HISTORIC DISTRICT COMMISSION

MEMORANDUM

Re: 808 W Washington HDC application (HDC24-0014)

ADDRESS: 808 W Washington Street, Application Number HDC24-0014

SITE PLAN and NOTES

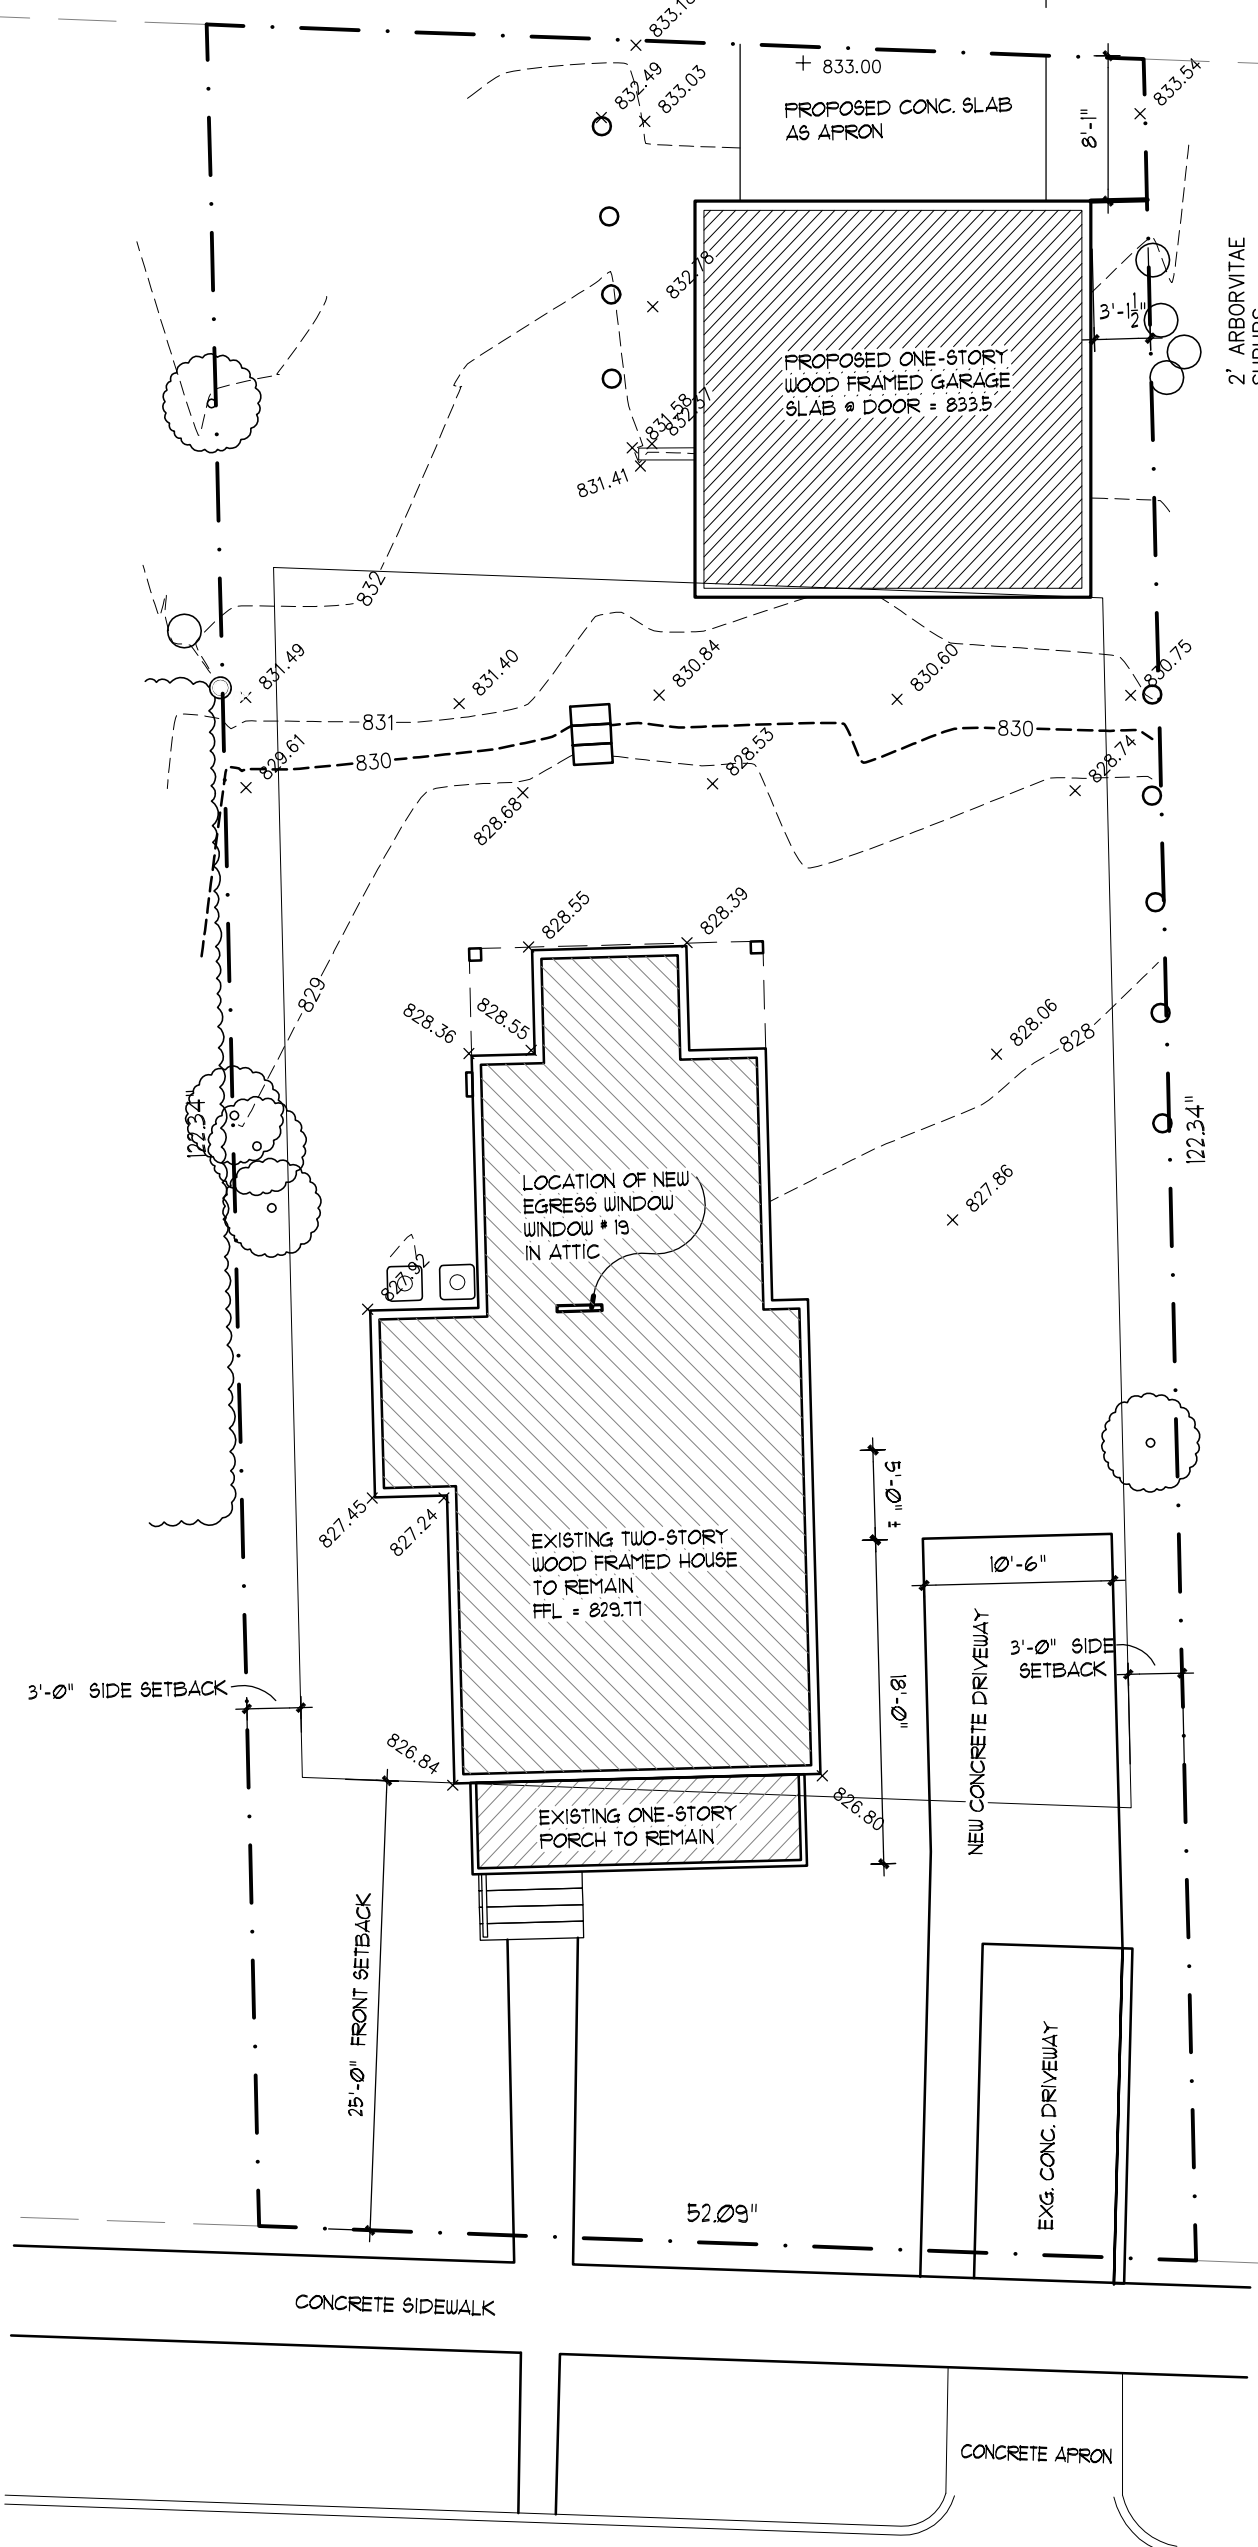
At the Historic District Commission's March 14 meeting, a portion of an application for 808 W Washington was postponed to the April 11, 2024 meeting. The HDC requested updated drawings for a proposed driveway that accurately reflect the location of a landmark tree and the driveway's width and placement on the lot. That drawing is attached, along with the March 14 staff report. Standards, guidelines and comments that relate to this portion of the original application are shown below.

1. The existing driveway is approximately 9' wide by 18' deep, the size of a typical parking space. The proposed concrete driveway is 10'6" wide and approximately 40' deep, which will hold two cars. The driveway is set back 3' from the side property line and 5' from the trunk of the large tree along the east property line that was present during the period of significance (and is therefore a historic feature of the lot).

2. Staff believes that the change to the side yard from the drive extension is detrimental to the property and neighboring properties by allowing an additional car to be parked in the side yard. By adding cars to the side yard, the driveway extension does not retain the historic relationship between the house, landscape features, and open space. The current single-car parking space is awkwardly located in the front yard, but has been that way since at least 1947. Staff believes that adding another car between this house and the neighboring house doesn't preserve historic relationships or landscapes and is visually incompatible with the site.

NEW GARAGE FOR: 808 WEST WASHINGTON STREET

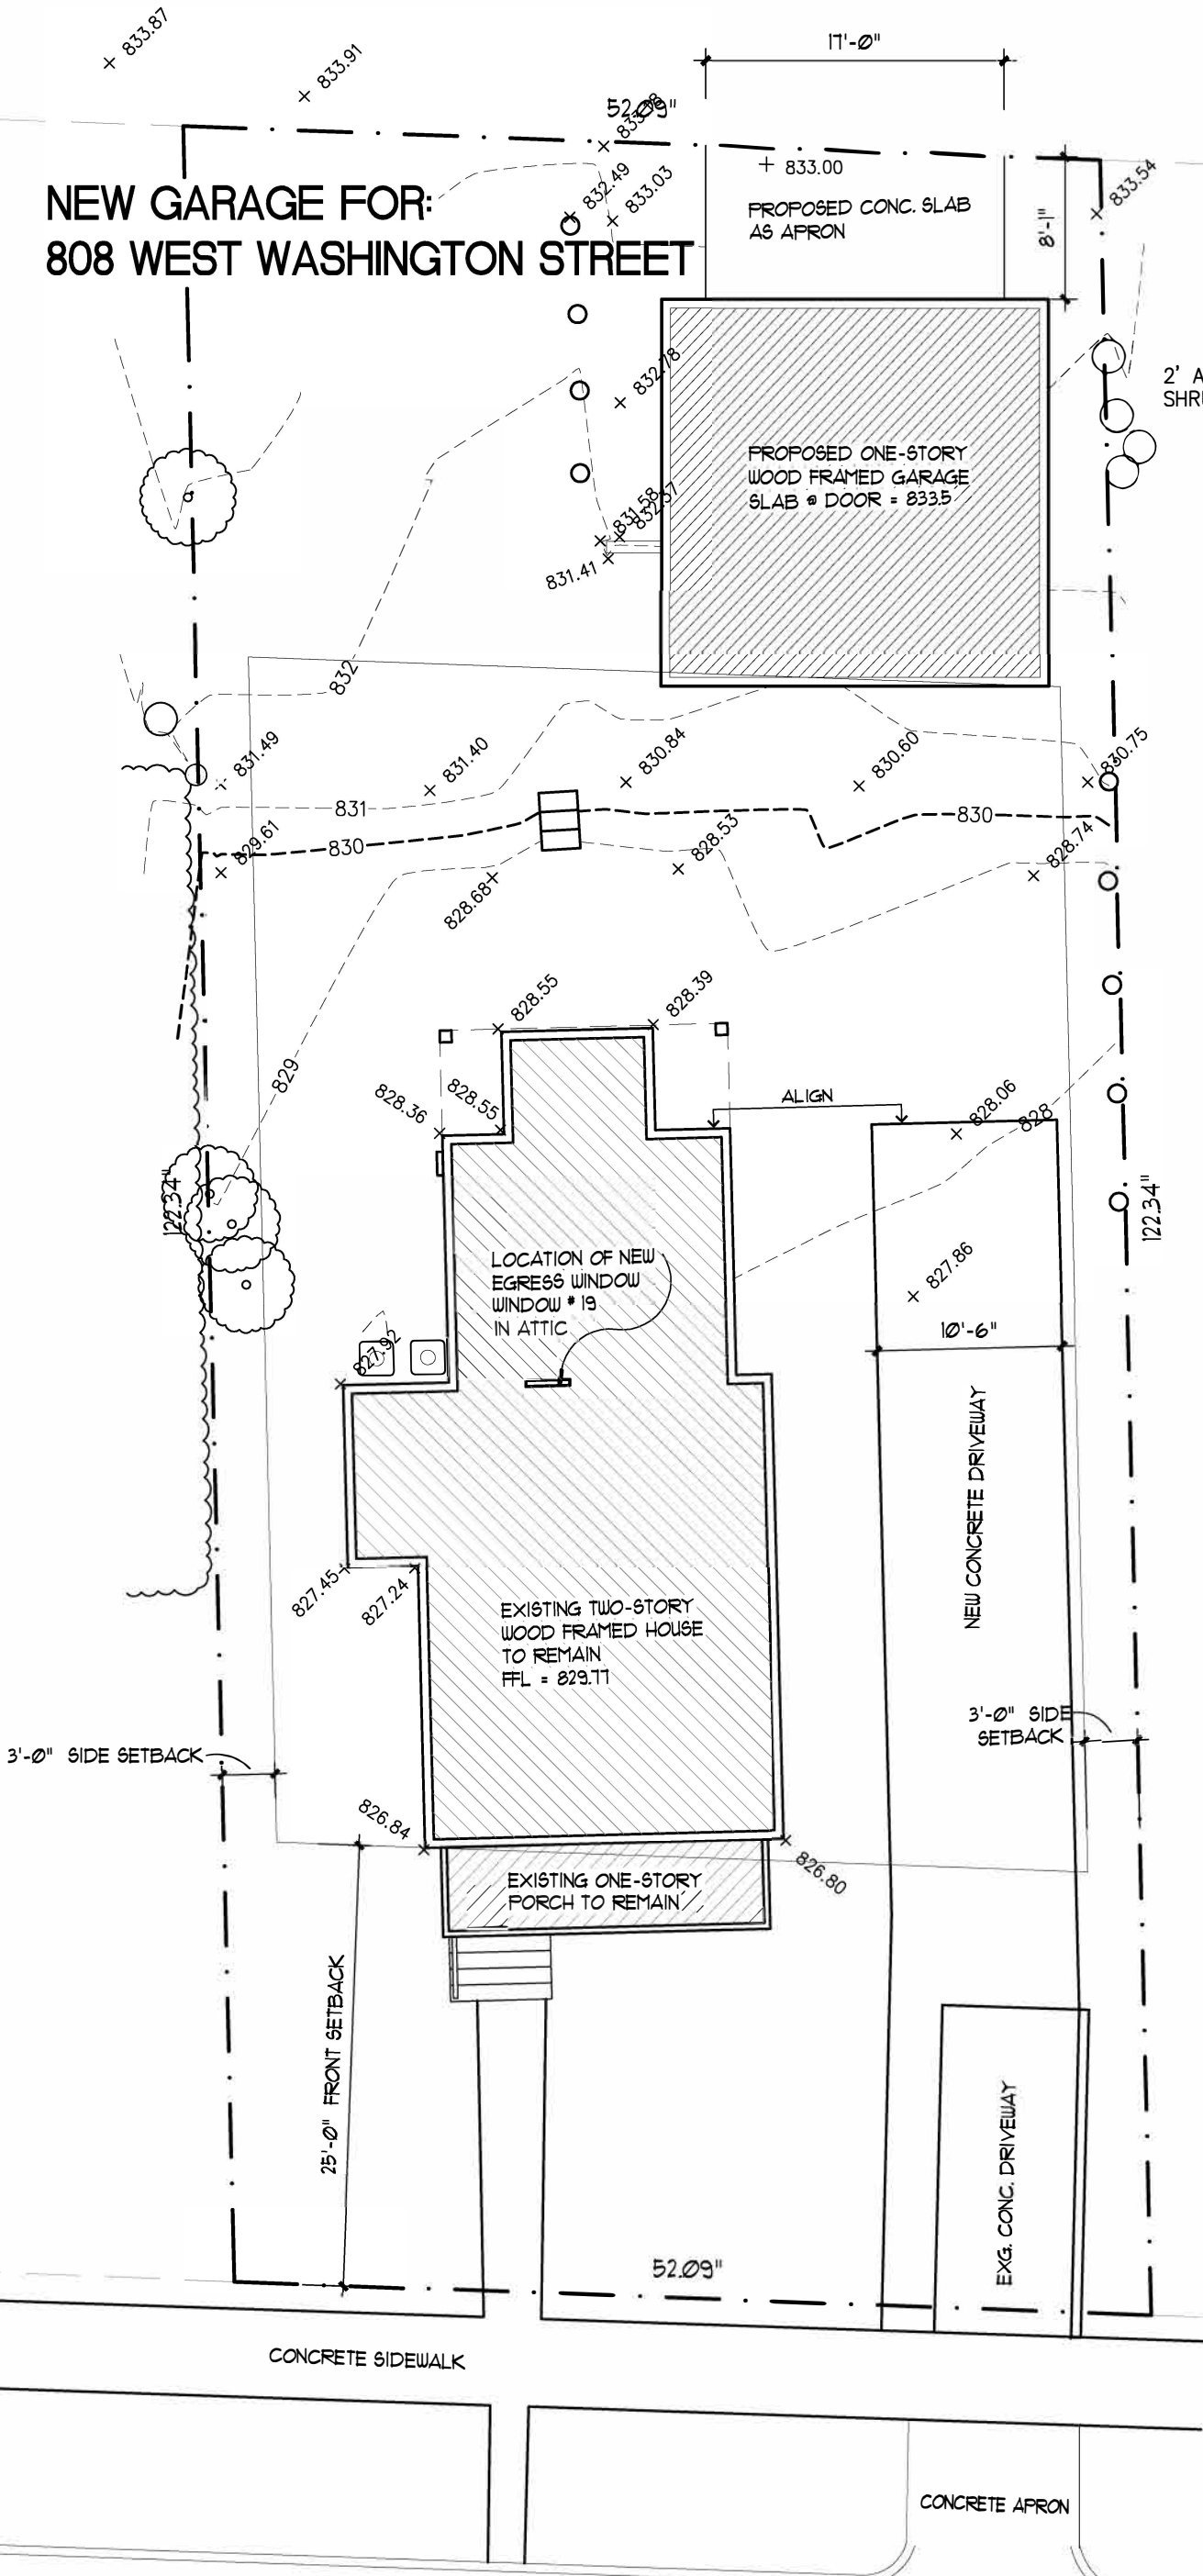
3. A driveway extension was added on to the last iteration of the plan to be submitted. Staff had not discussed this driveway with the applicants. The current driveway off West Washington is approximately 9' wide x 18' deep (the size of a single parking space). The new driveway is 10'6" wide by approximately 70' deep. It extends to the back corner of

the house. Near the east lot line, Google Street View shows a very large maple tree that is in the way of the driveway and appears to be a landmark tree.

The driveway extension is problematic. The driveway in its current extent is shown on the 1947 city aerial, as is the maple tree. The applicant is requesting three driveway parking spaces where one exists now, plus two garage parking spaces. Staff believes that the change to the side yard from the drive extension is more visible and detrimental to the property and neighboring properties and the landmark tree than the construction of the garage. By adding cars to the sideyard, the driveway extension does not retain the historic relationship between the house, landscape features, and open space.

REAR ELEVATION FOR NEW WINDOW

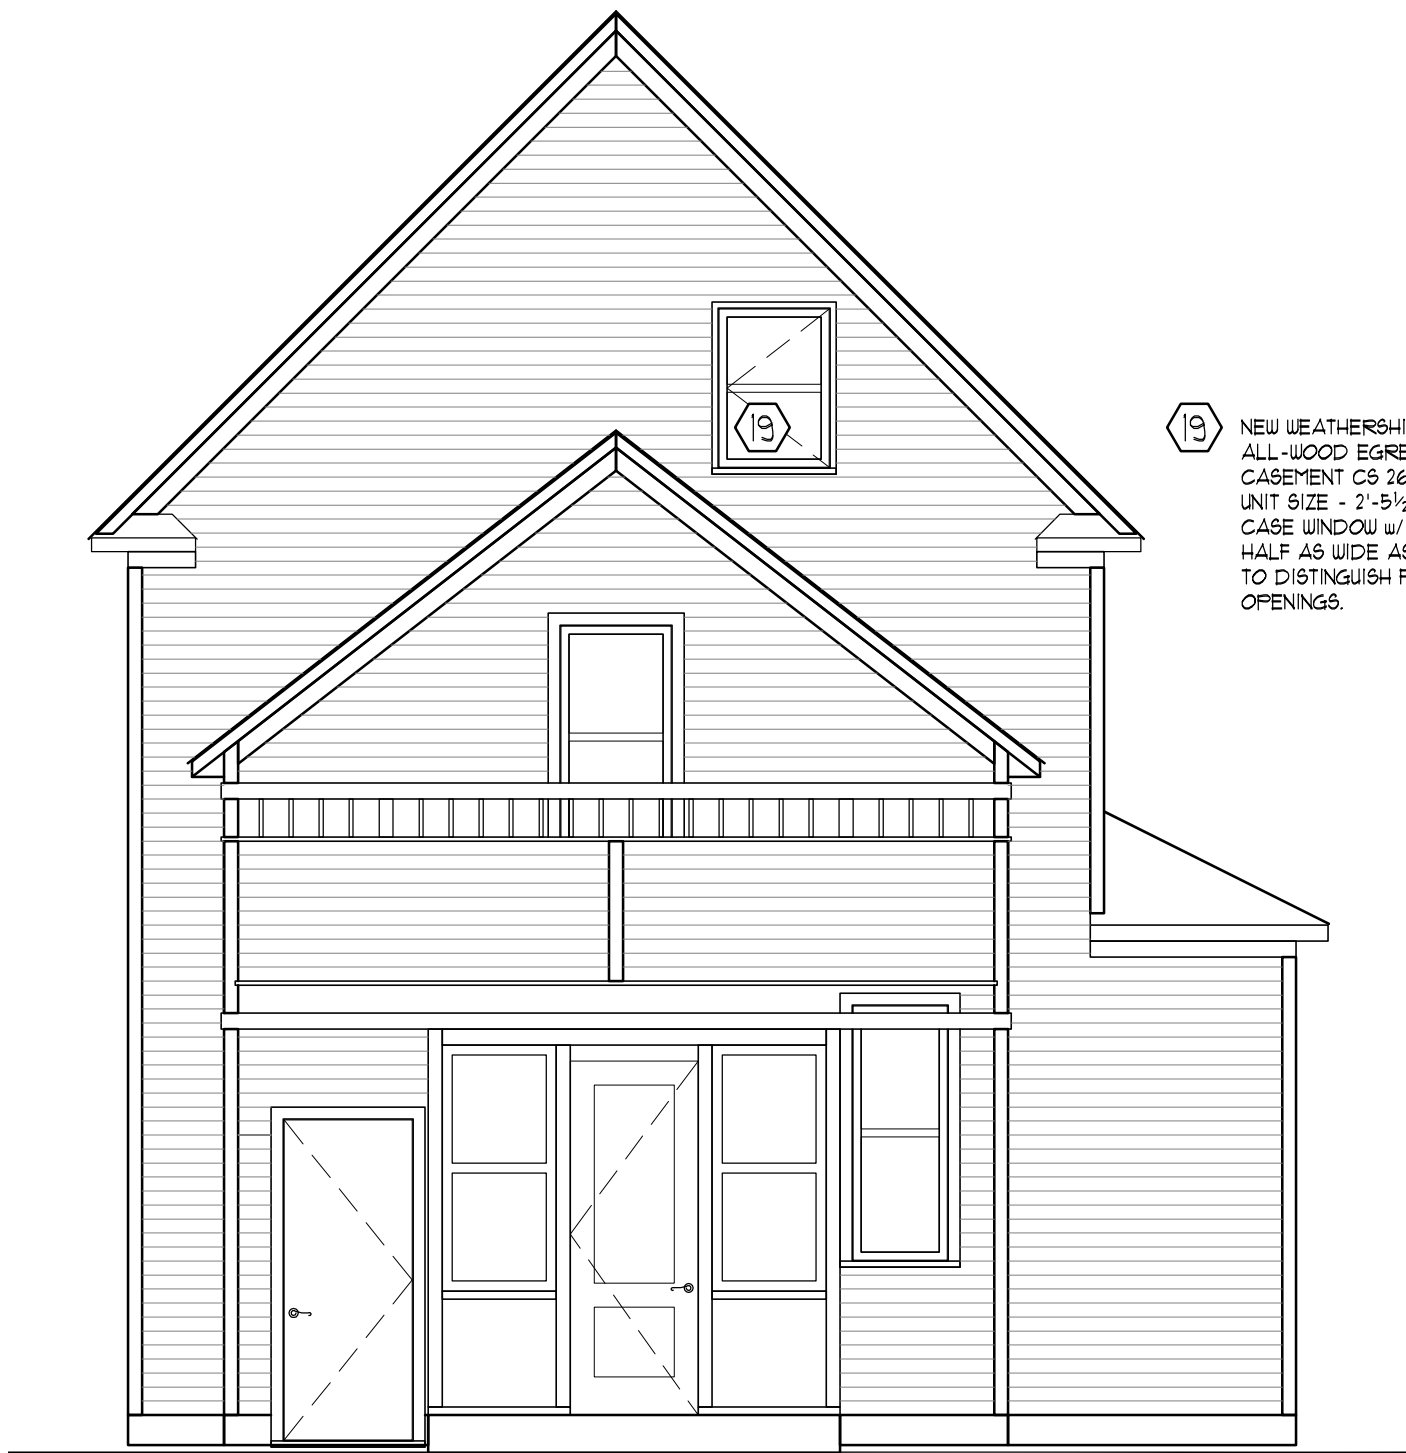
4. The attic window is in an appropriate location, has a false muntin across the center to make it appear like a one-over-one sash instead of a casement, and the trim is half the width of the historic trim to distinguish this as a new opening. The proposed window is an all-wood Weathershield that is 2'5 1/2" x 3'5 1/2". Staff supports the additional window since it is on the rear elevation and allows the utilization of attic space.
5. Staff has suggested two motions below. The first is for the garage and attic window, and staff recommends approval. The second is for the driveway extension, which staff does not support for the reasons stated above.
